Access Compliance Report

Public Rights-of-Way

Intersection ID: 13736	Main Street: CAMDEN_RD	Cross Street: N/A	Location: SE
ADA ID: 9912688E5FFE	Ramp Type: BlendTrans2	Initial Pass/Fail: Fail	Overall Compliance: No
Severity Score: 1.25			
Codes/Mitigation Info/Possible Solution		Field Measurements/Component Compliance

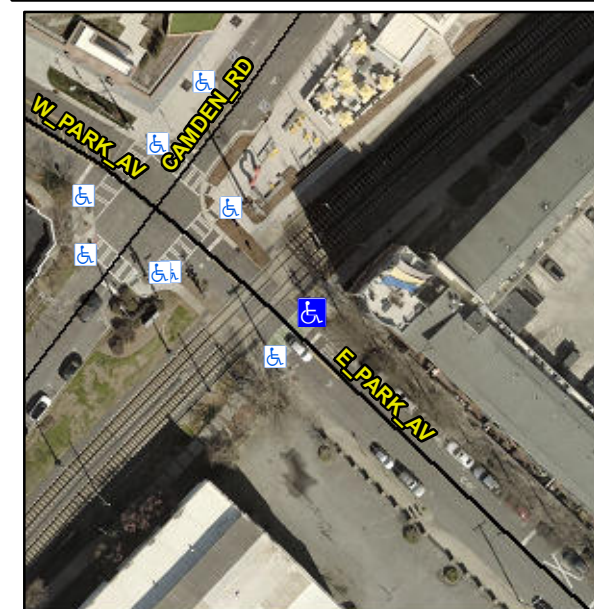
R304.5.3

Compliance	Description	Data	Compliance	Description	Data
N/A	Ramp Length (in)	51.0	Yes	BlendTrans Slope (%)	2.2
Yes	Ramp Width (in)	95.0	No	BlendTrans XSlope (%)	5.0
N/A	Flare Type LT	N/A	N/A	Flare Type RT	N/A
N/A	Flare Slope LT (%)	N/A	N/A	Flare Slope RT (%)	N/A
N/A	Flare Traversable LT?	N/A	N/A	Flare Traversable RT?	N/A
N/A	Landing Length (in)	N/A	N/A	DWS Provided?	N/A
N/A	Landing Width (in)	N/A	N/A	DWS Contrast?	N/A
N/A	Landing Slope (%)	N/A	N/A	DWS Length (in)	N/A
N/A	Landing X Slope (%)	N/A	N/A	DWS Full Width?	N/A
N/A	Landing Curb? (Y/N)	N/A	N/A	DWS Offset (in)	N/A
N/A	Shared Landing?	N/A			
N/A	Gutter Ponding?	N/A	N/A	Gutter Slope (%)	N/A
N/A	Gutter Lip Ht (in)	N/A	N/A	Gutter X Slope (%)	N/A
N/A	Painted X Walk1?	Yes	N/A	Painted X Walk2?	N/A
	X Walk 1 Direction	To SW		X Walk 2 Direction	N/A
	X Walk 1 Width (in)	112.0		X Walk 2 Width (in)	N/A
	X Walk 1 Slope (%)	0.7		X Walk 2 Slope (%)	N/A
	X Walk 1 X Slope (%)	3.7		X Walk 2 X Slope (%)	N/A

Remove & Replace Curb Ramp With Two New Directional Ramps or Equivalent.
